UNITED STATES PATENT AND TRADEMARK OFFICE

APPLICATION NO.	FILING DATE	FIRST NAMED INVENTOR	ATTORNEY DOCKET NO.	CONFIRMATION NO.
09/538,754	03/30/2000	Michael Alexandrovich	Alexandrovich 1-12-9	8954

Office Action Summary

DETAILED ACTION

FIG. 3C

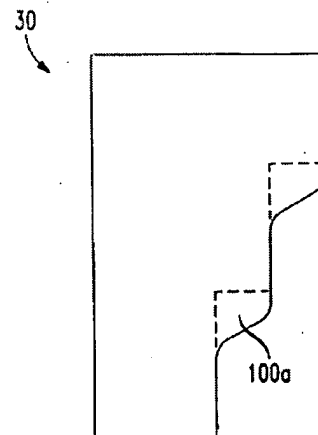
Rinaudo et al ("Rinaudo" hereinafter) show a controlled multi-wavelength etalon comprising:

a first planar reflecting surface;

a second planar reflecting surface positioned parallel to and at a first distance from the first planar reflecting surface;

a third planar reflecting surface positioned parallel to and at a second distance from the first planar reflecting surface, the second distance being greater than the first distance, the second planar reflecting surface having a first edge and the third planar reflecting surface having a second edge, the first and second edges facing one another; and

a step having a sloping planar surface adjoining the first and second edges.

With regards to claim 2, the step is positioned such that a portion of a light passing through the first planar reflecting surface impinges on the sloping planar surface at an angle such that it passes through the sloping planar surface.
